Re: NYISO 2021-2025 ICAP Demand Curve Reset Process  
Comments on NYISO Staff Final Recommendations

**Comments of GenOn Bowline, LLC and GenOn Energy Management, LLC  
on NYISO Staff Final Recommendations for the 2021-2022 ICAP  
Demand Curves and the Parameters for the  
2021-2025 Demand Curve Reset Process**

# Interruptible at AGT Ramapo scarce since Q1 2019 - AGT daily interruptible percentage on a daily basis per month at the Ramapo MPC-AGT interconnect in NY

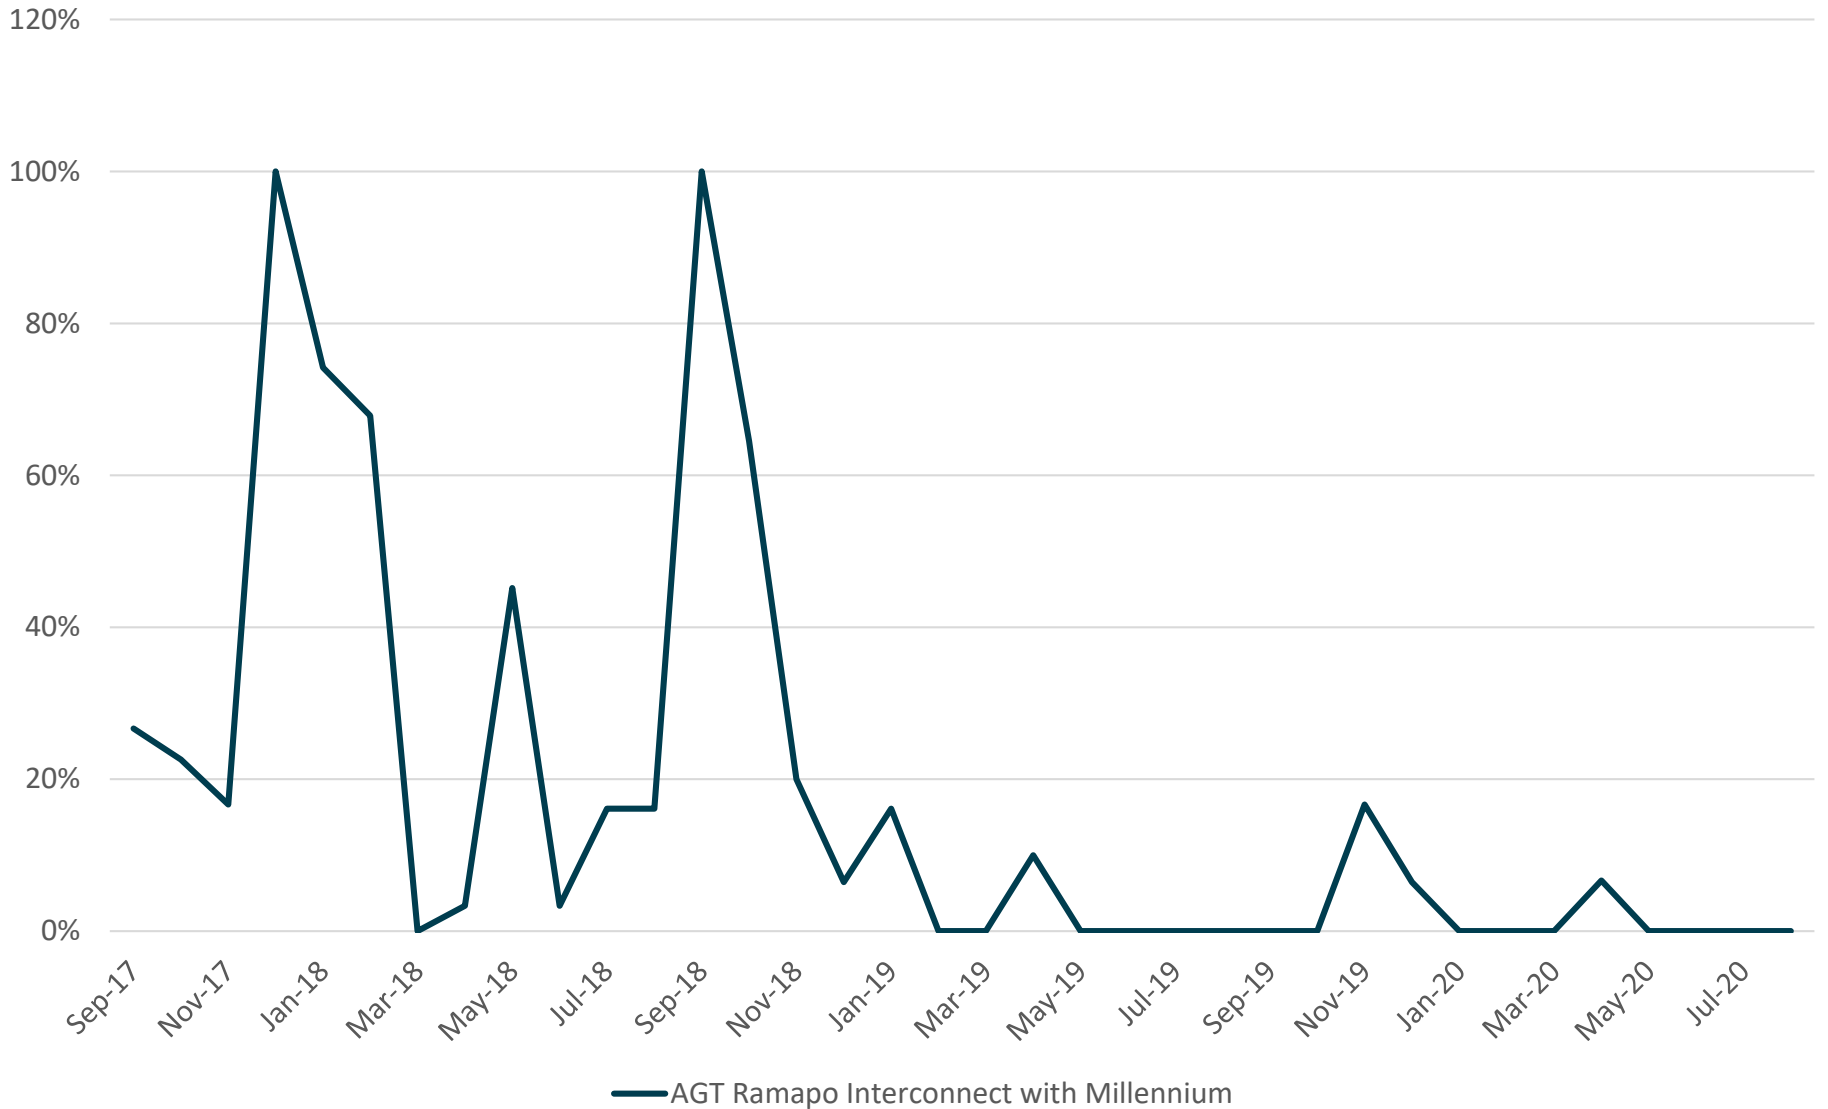
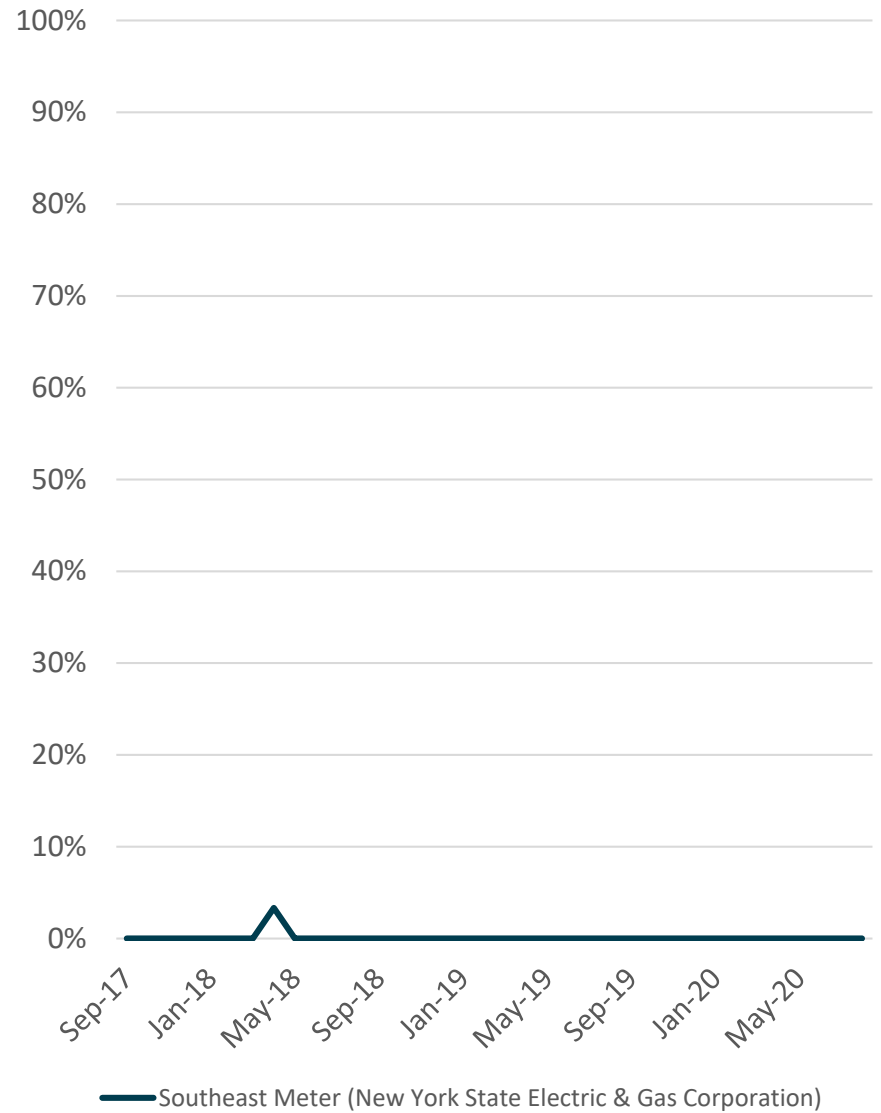
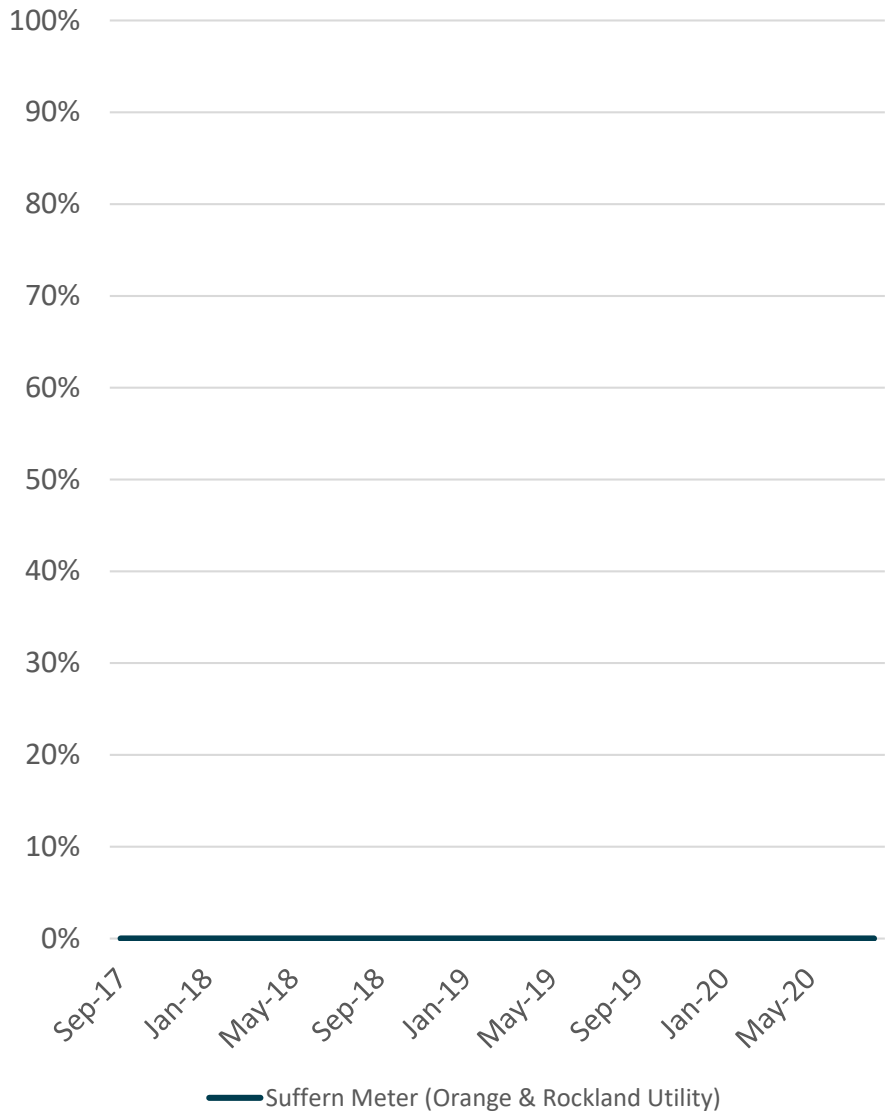
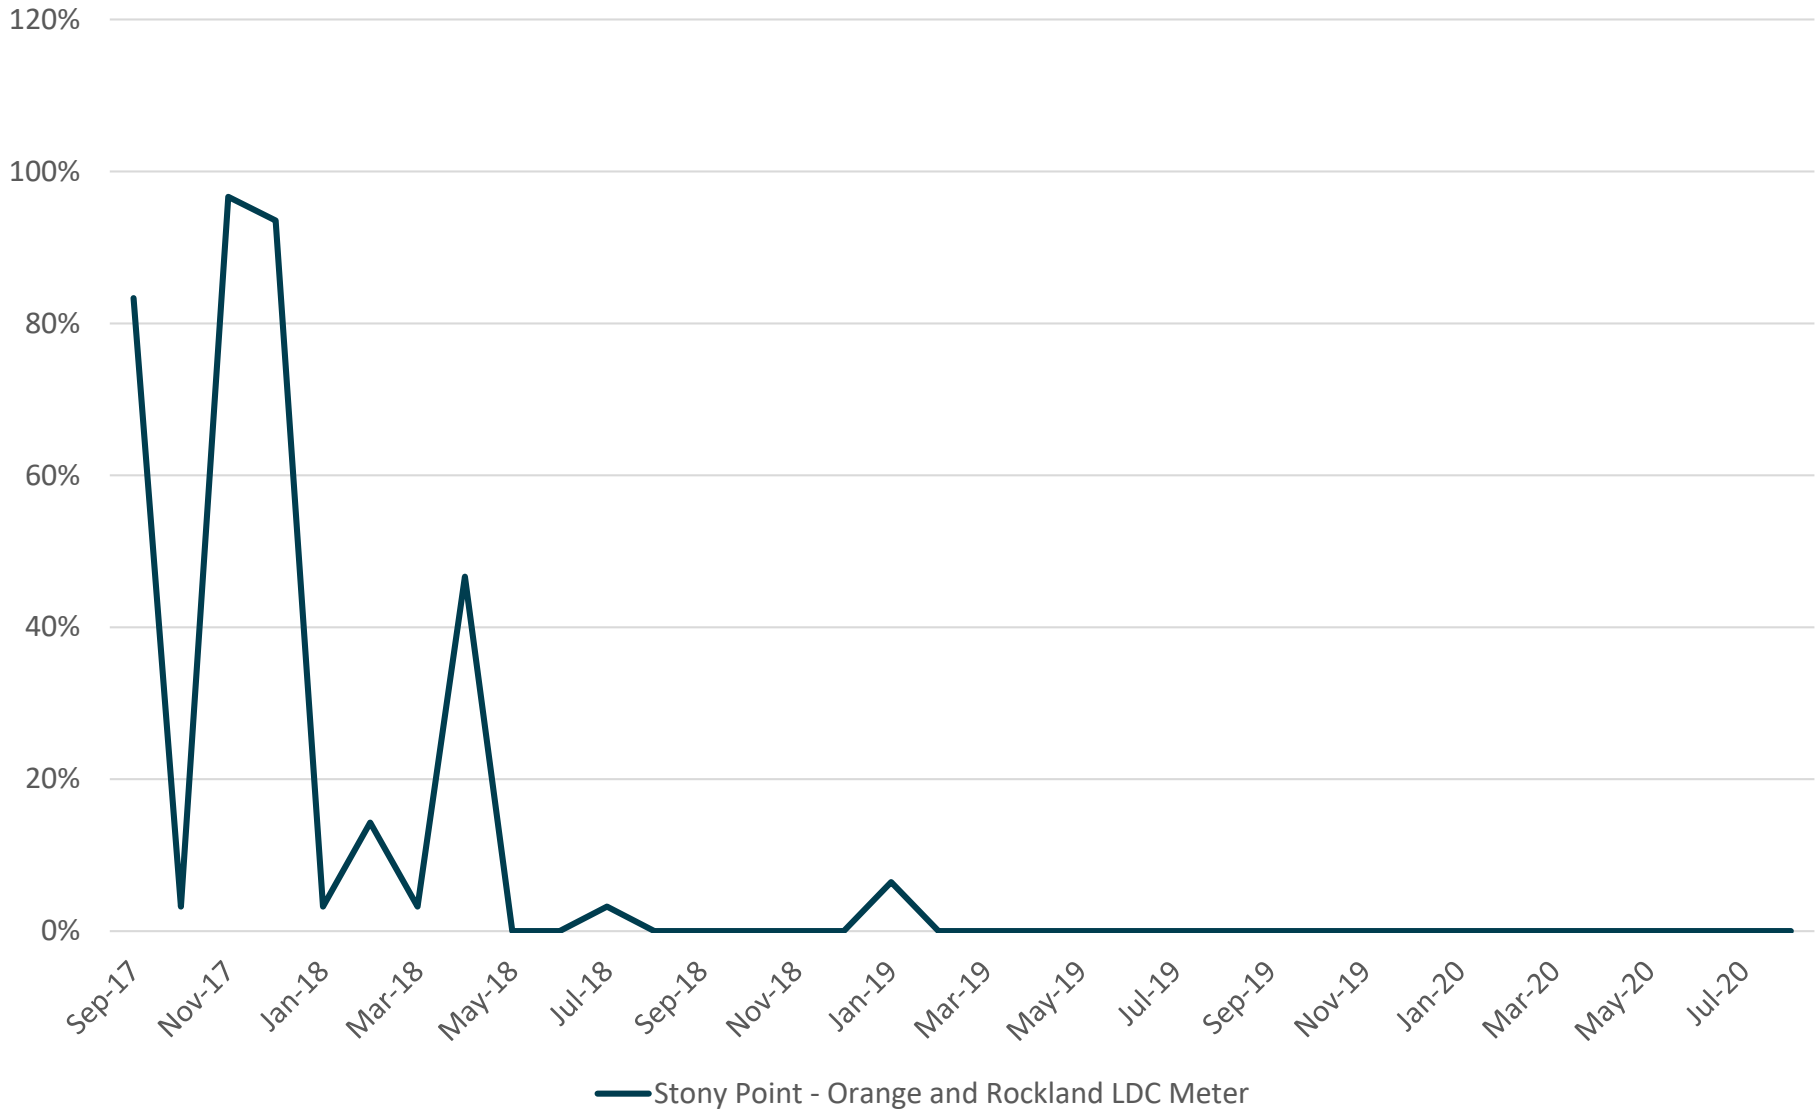
service was available *at all* during either the summer or winter peak operating periods in 2019 and 2020.<sup>36</sup>

<sup>36</sup> See Attachment 3 (registering 0% availability during peak summer and winter months).

AGT daily interruptible *not available at all* for LDC in Rockland county where the modeled NYISO plant would be located - percentage on a daily basis per month at the Suffern LDC in Rockland County NY and Southeast LDC in Putnam County NY

# AGT daily interruptible not available for LDC in Rockland county since Q1 2019 - AGT daily interruptible percentage on a daily basis per month at the Stony Point LDC in NY

## Flows East on Millennium at Wagoner West Compressor

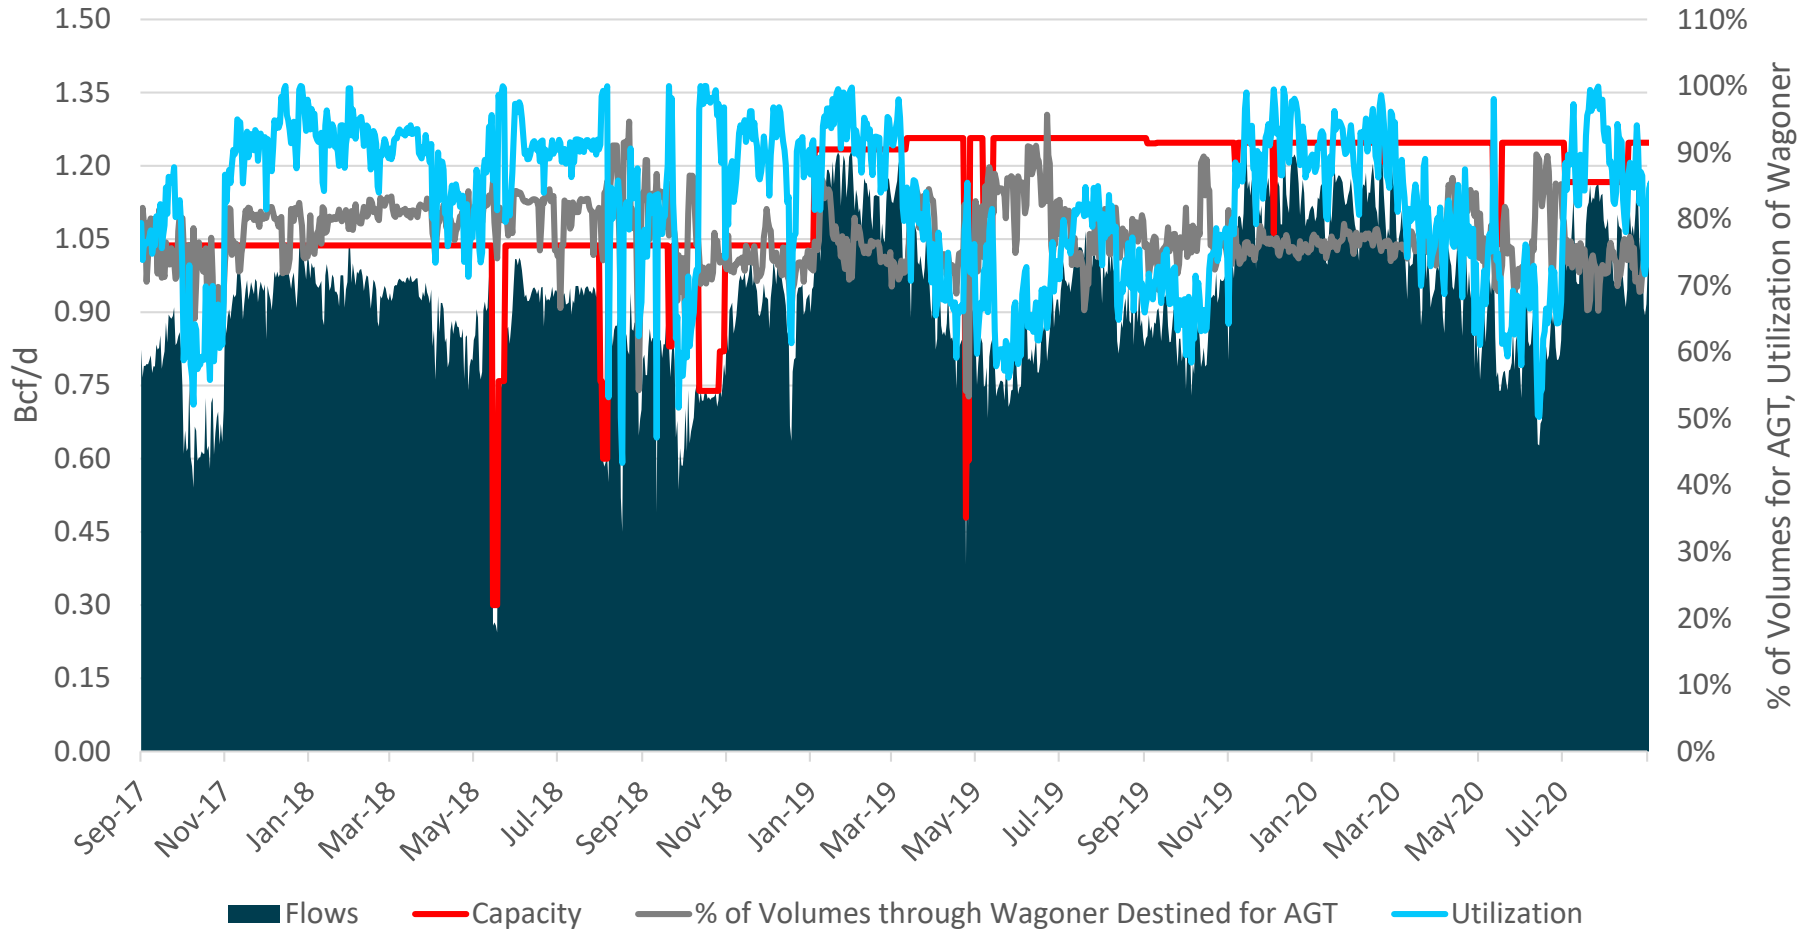
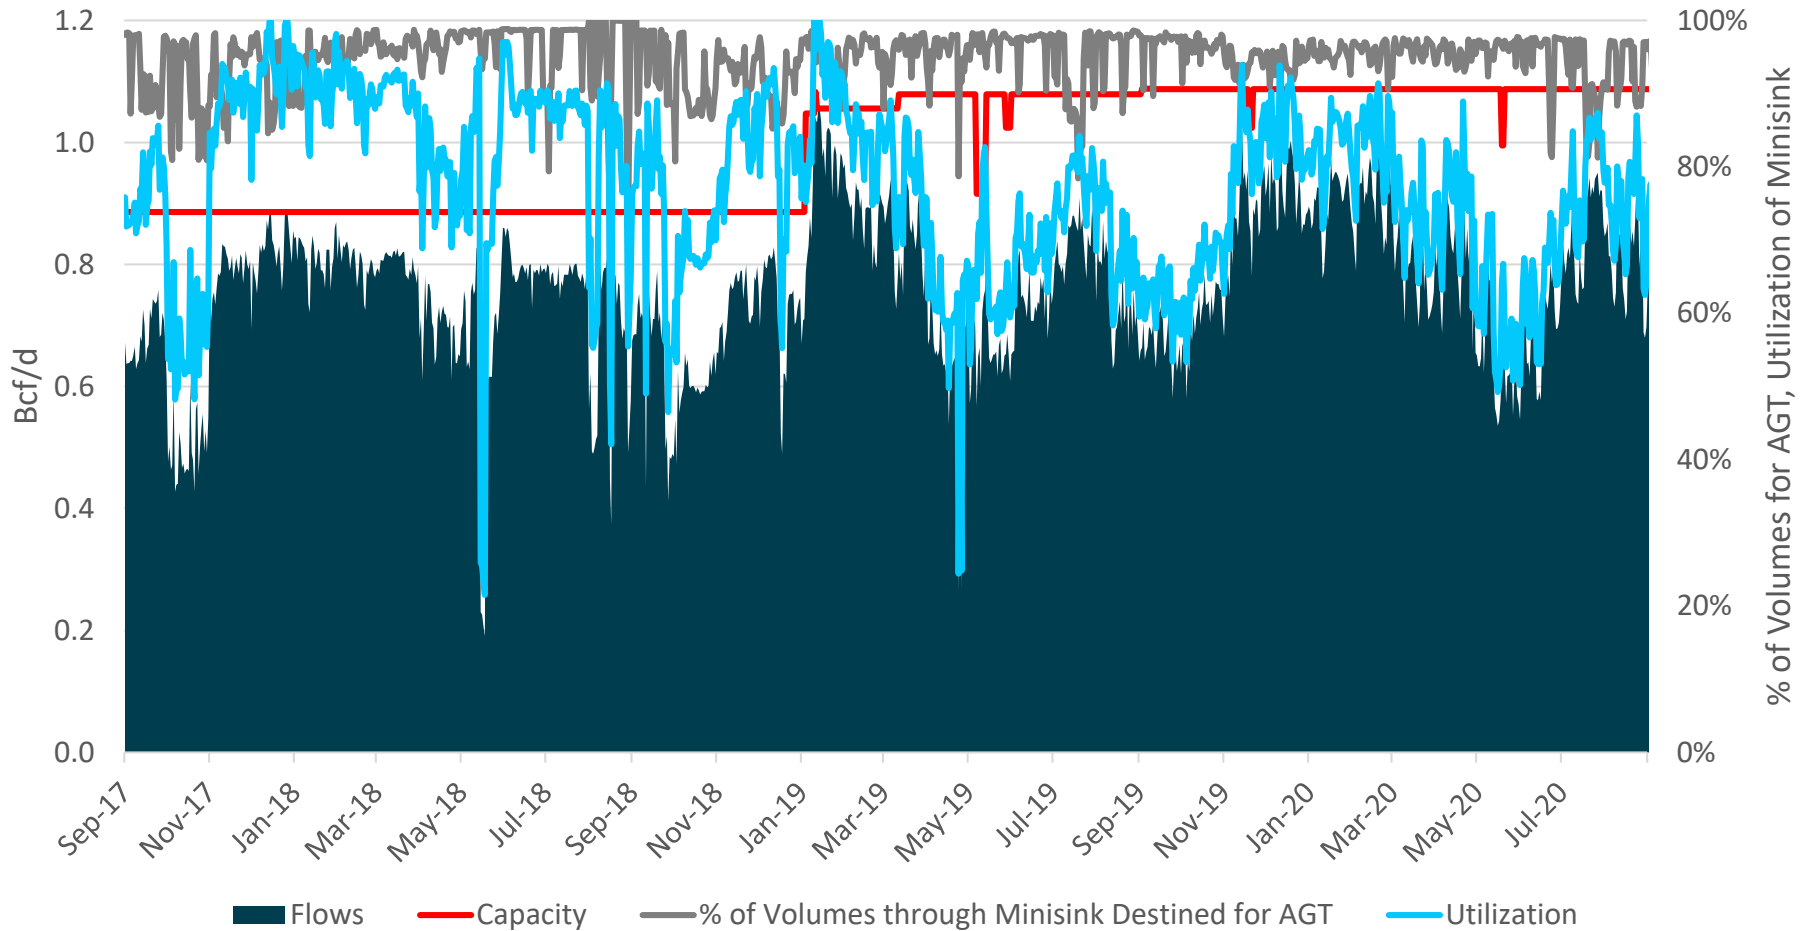
Rockland County using this line faces two constraint points in New York, the Wagoner West Compressor located in Sullivan County and the Mini-sink compressor station located in Orange County. Open operational capacity must be available at both points. Attachment 6 establishes that operational supply constraints in peak winter months across the three years reduced expected generation by 24% over the entire period.<sup>42</sup> In the winter of 2019-2020, operational constraints reduced expected generation by 90% with attendant reliability consequences in Zone G.<sup>43</sup>

Millennium is highly utilized in winter to meet demand on system as well as provide supply to AGT. LDCs and CPV own 56% of FT capacity through Wagoner West compressor station, producers own 33% of FT, Columbia Gas owns 10% of FT, and marketers own 2% of FT

Almost 100% of the gas flowing through the Minisink compressor station is destined for Algonquin Pipeline and would require a power plant to pay an Algonquin City Gate price for delivery in Rockland County.

## Monthly Modeled Generation Scenarios –Wagoner & Minisink

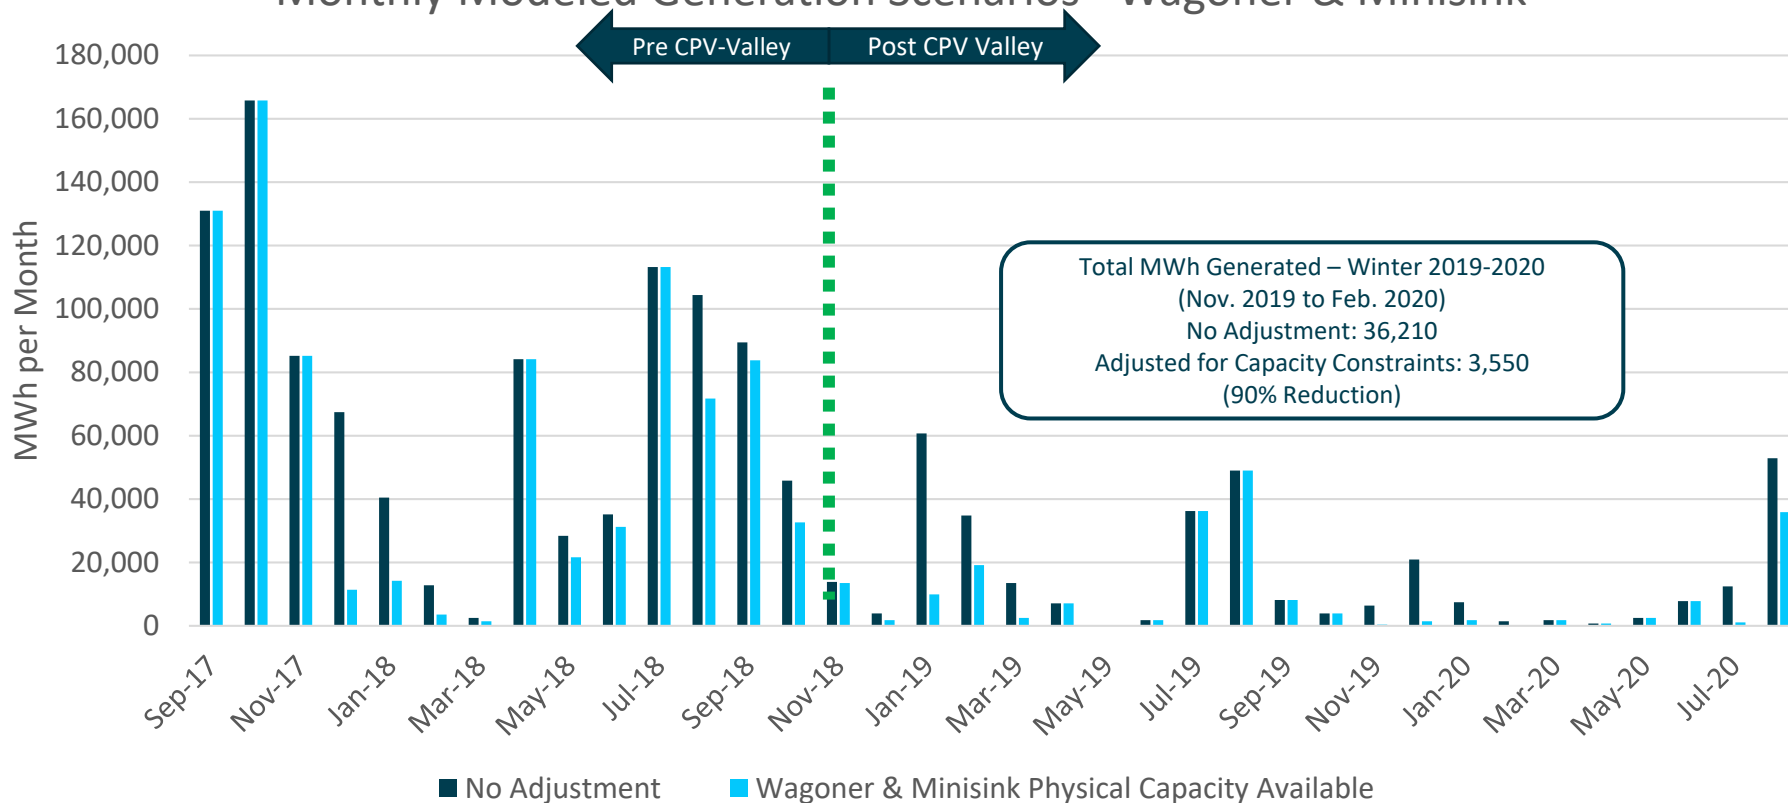
# Monthly modeled generation scenarios using TETCO M3 pricing and constraints at both Wagoner West and Millennium Minisink compressors highlight significant winter capacity constraints on Millennium

Total MWh Generated – Total Period (Sept 2017 to Aug 2020)  
 No Adjustment: 1,269,480  
 Adjusted for Capacity Constraints: 967,375 (24% Reduction)
